## **IFB ADDENDUM #2**

Re: IFB 2023-10 City View Towers Electrical Upgrade

This Addendum modifies and forms a part of the Bid Set documents dated December 13, 2023.

**1 BASEMENT PLAN - DEMOLITION**  
SCALE: 1/8" = 1'-0"

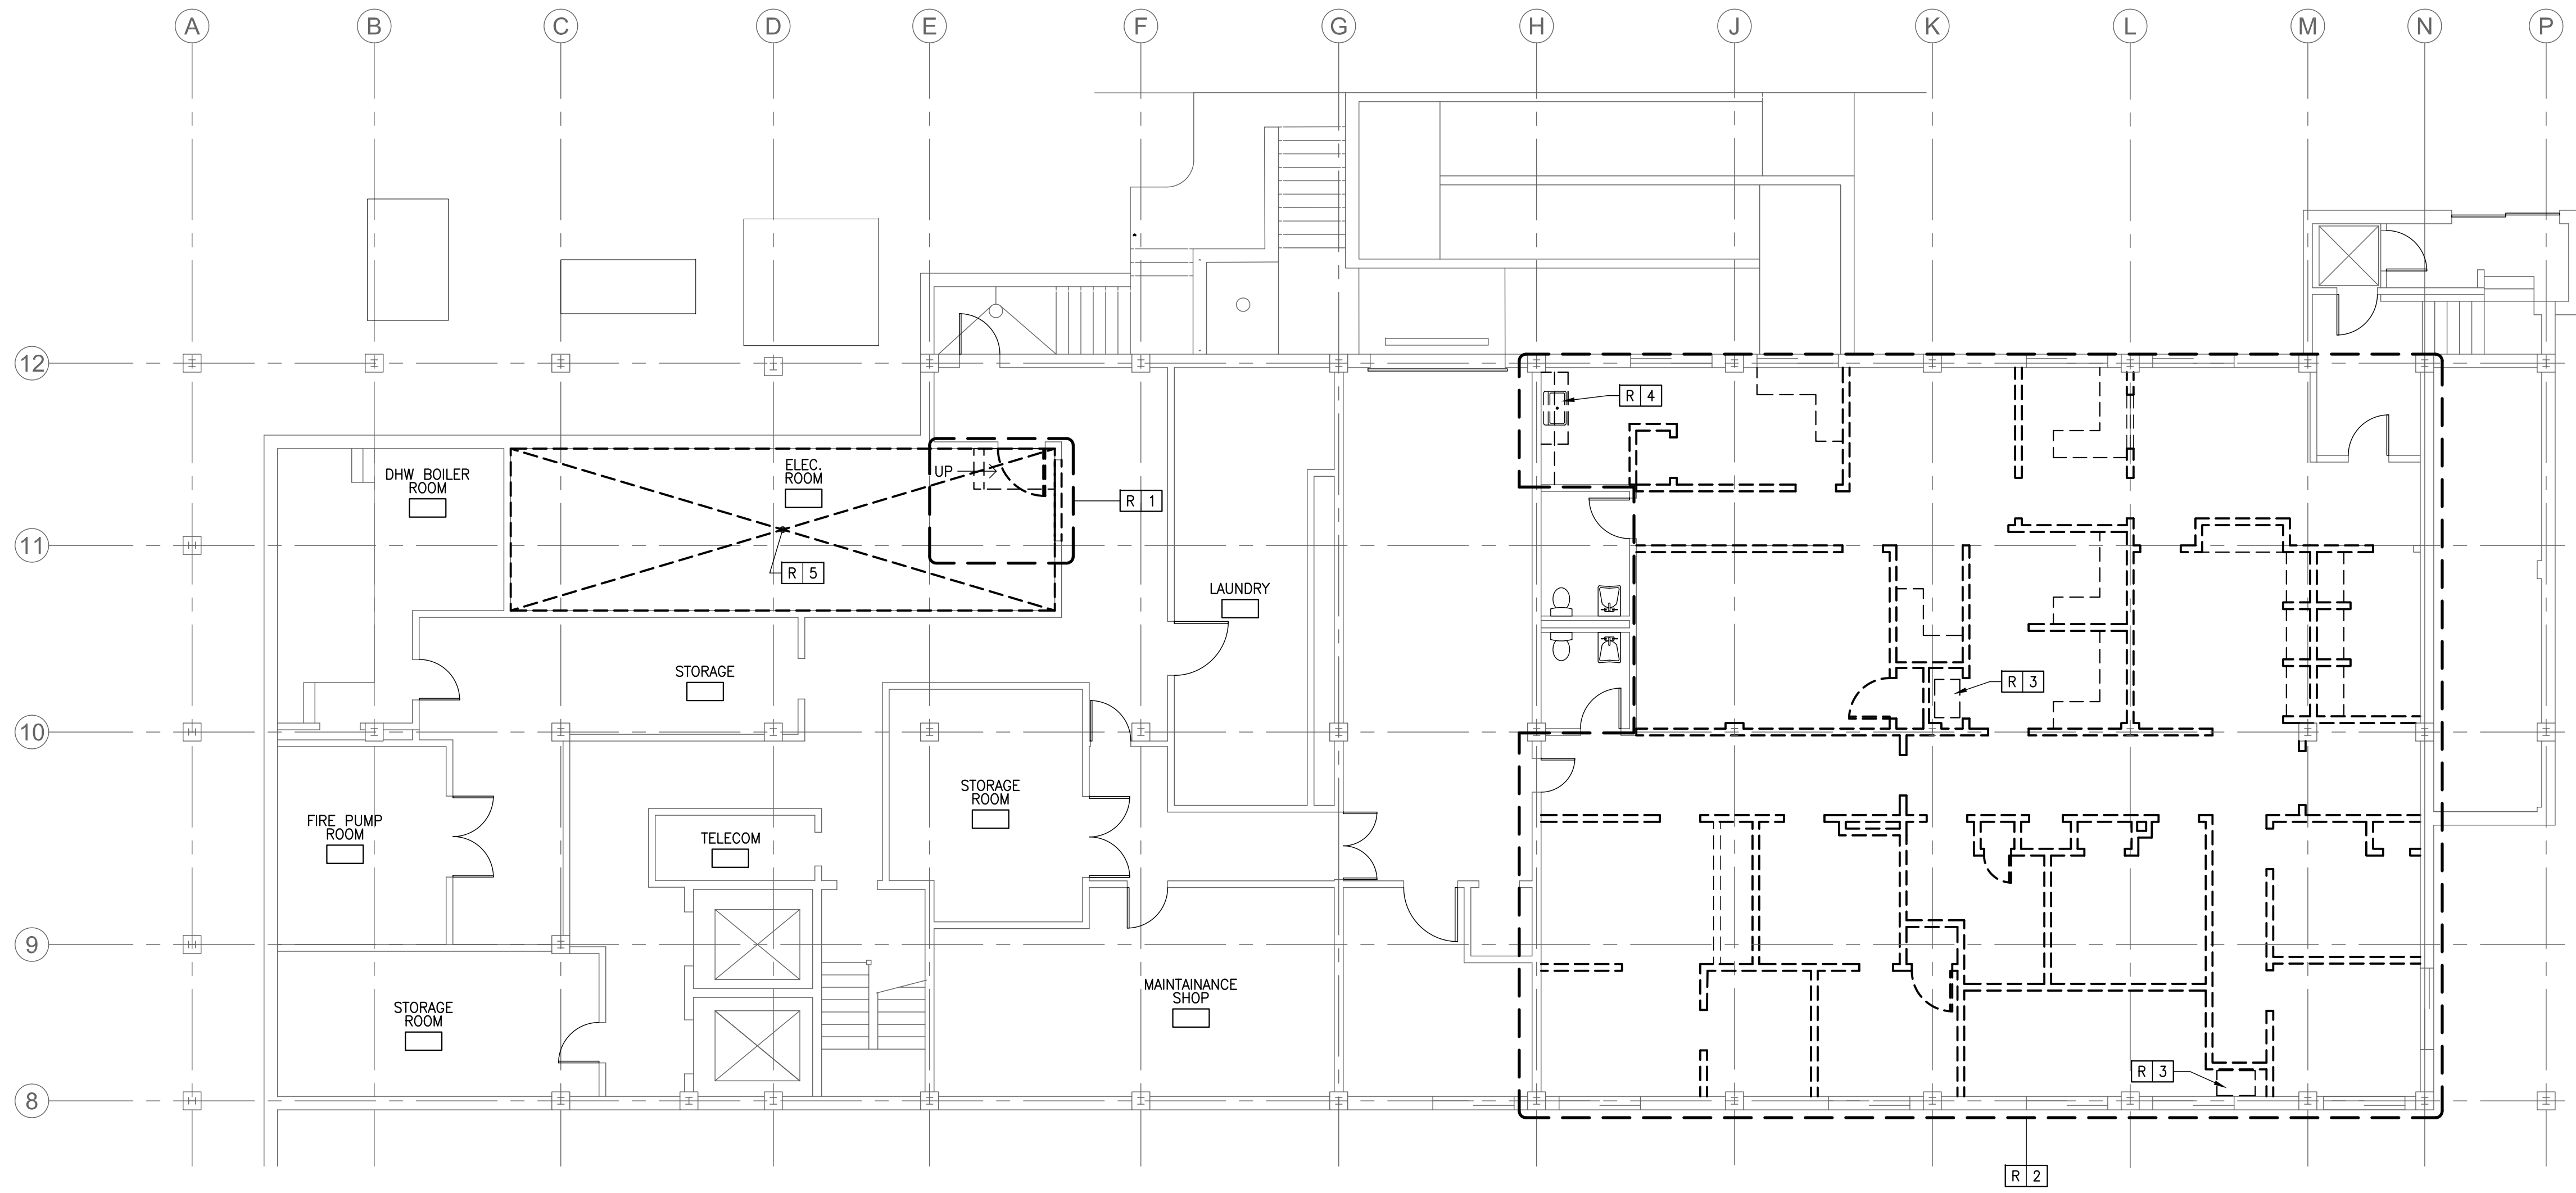
#### **Drawing AD.01 - Basement Plan - Demolition**

1. Scope of Work Note R-2: Scope of Work R-2: Delete "VCT" and replace with "Ceramic Tile".  
Add sentence: - (R) All mortar and grout leaving a smooth concrete floor.

**R 2** **EXISTING OFFICES**  
-(R) ALL PARTITIONS INDICATED BY DASHED LINE UP TO DECK ABOVE.  
-(R) ALL DOORS AS INDICATED BY DASHED LINE.  
-(R) ALL SUSPENDED CEILINGS. (E) SPRINKLER HEADS TO REMAIN  
-(R) ALL COUNTERS, CABINETS, BUILT IN DESKS, ETC.  
-(R) ALL CERAMIC TILE FLOORING EXCEPT WITHIN RESTROOMS SHOWN TO REMAIN.  
-(R) ALL MORTAR AND GROUT LEAVING A SMOOTH CONCRETE FLOOR.

PHASING NOTE

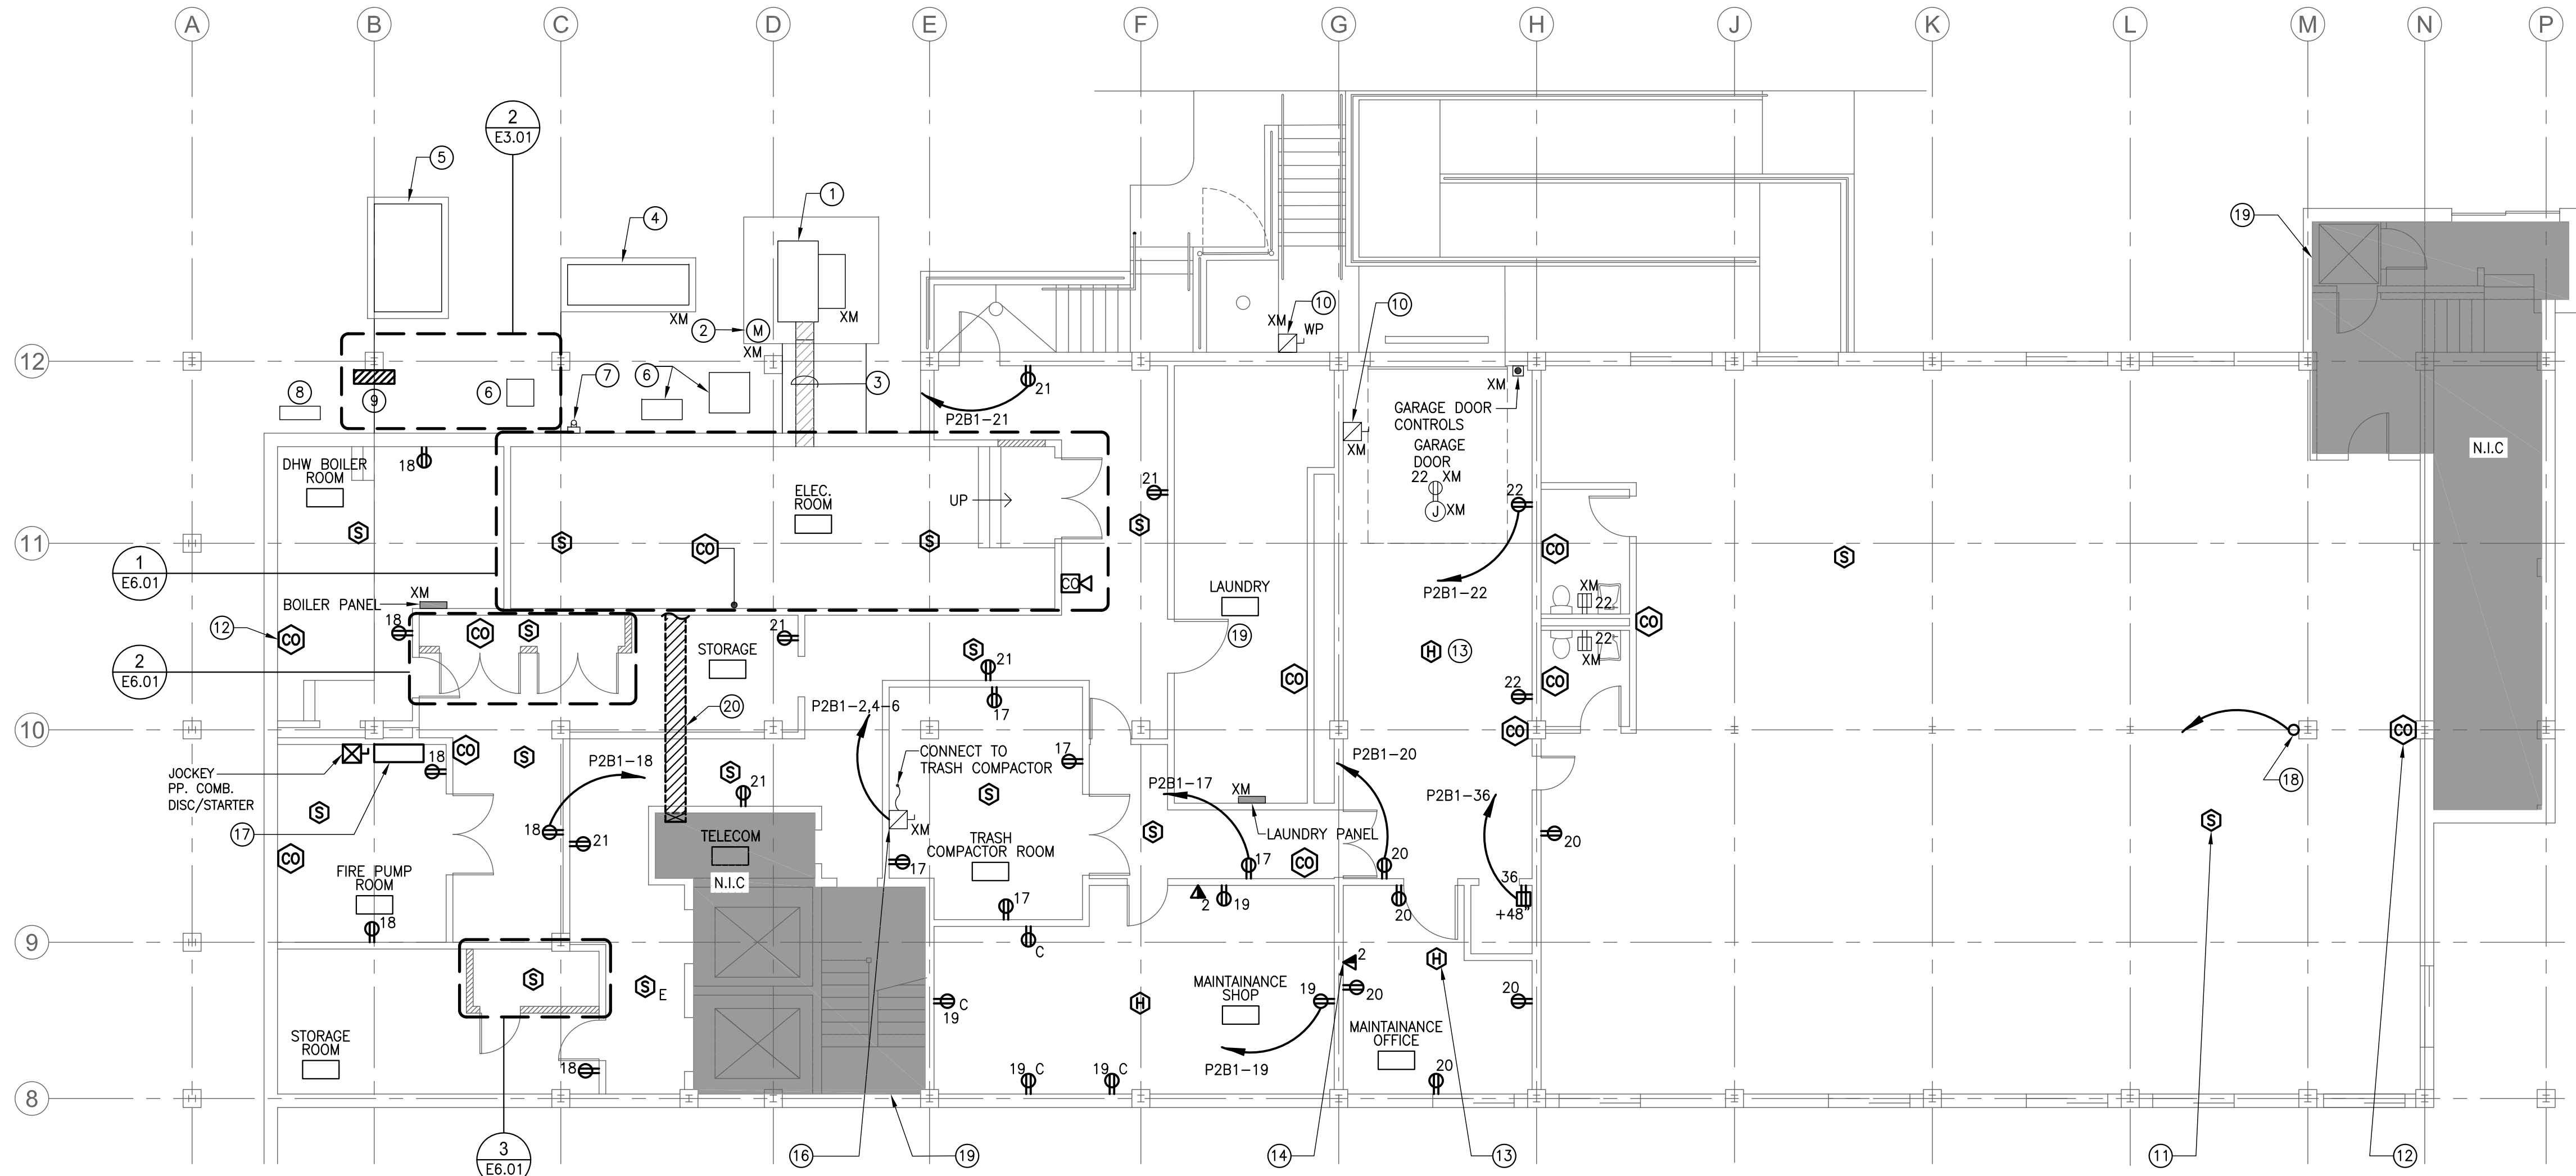
#### **Drawing E0.02 - Drawing E0.02 Electrical Abbreviations and General Notes:**

1. Add "Phasing Note: All temporary power rental equipment and associated cables shall be disconnected and removed by the rental company: Infra-Red Building & Power Service of Holbrook, MA (781) 767-0888 under a separate contract. Provide coordination of all required shutdowns between the Owner and Infra-Red BPS."

ALL TEMPORARY POWER RENTAL EQUIPMENT AND ASSOCIATED CABLES SHALL BE DISCONNECTED AND REMOVED BY THE RENTAL COMPANY: INFRA-RED BUILDING & POWER SERVICE OF HOLBROOK MA (781)767-0888. UNDER A SEPARATE CONTRACT. PROVIDE COORDIANION OF ALL REQUIRED SHUTDOWNS BETWEEN THE OWNER AND INFRA-RED BPS.
